8-F-24-HZ
APPLICATION FOR CERTIFICATE OF APPROPRIATENESS

Staff Report

File Number: 8-F-24-HZ

Location: 1209 Scenic Dr. **Parcel ID** 121 D C 043
District: Scenic Drive NC
Zoning: RN-1 (Single-Family Residential Neighborhood)
Description: Italianate, c.1925
Two-story, stucco-clad residence with a hipped roof and an exterior clad in stucco.

DRAWING TITLE
GARAGE ELEVATIONS

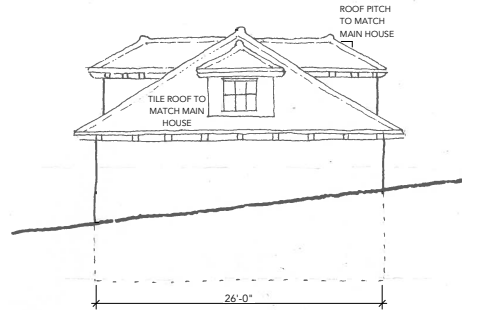
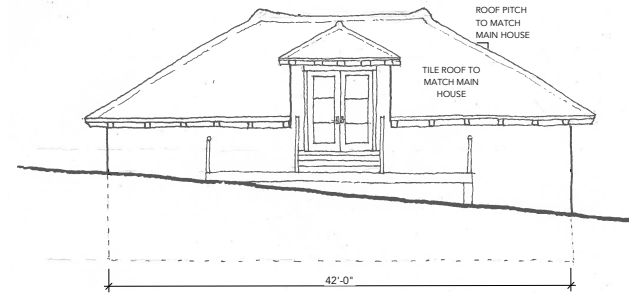
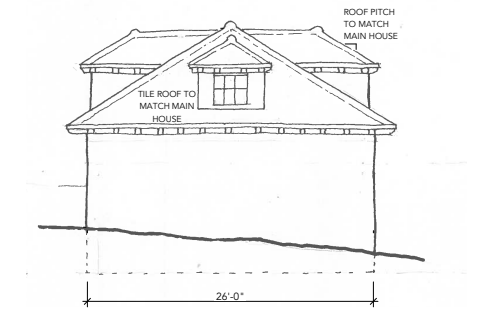
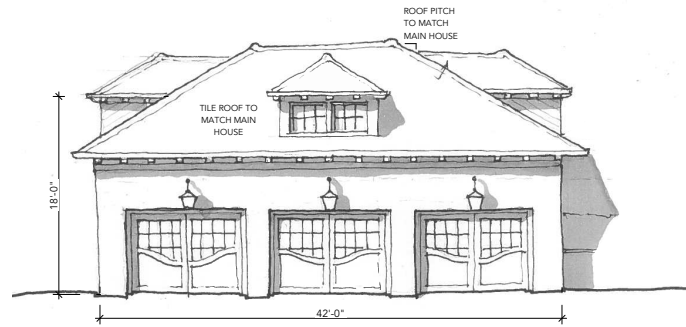
6. The new garage will be placed towards the rear of the lot, behind the primary structure, and features a design and materials consistent with the primary structure. No additional front yard parking will be created. The final site plan for garage access and any new driveway elements should meet City Engineering standards. Details on exterior cladding on the garage should be provided to staff for review.

Staff recommends approval of Certificate 8-F-24-HZ, subject to the following conditions: 1) omission of the proposed front porch addition; 2) final site plan to meet City Engineering standards; 3) garage cladding details to be provided to staff for review.
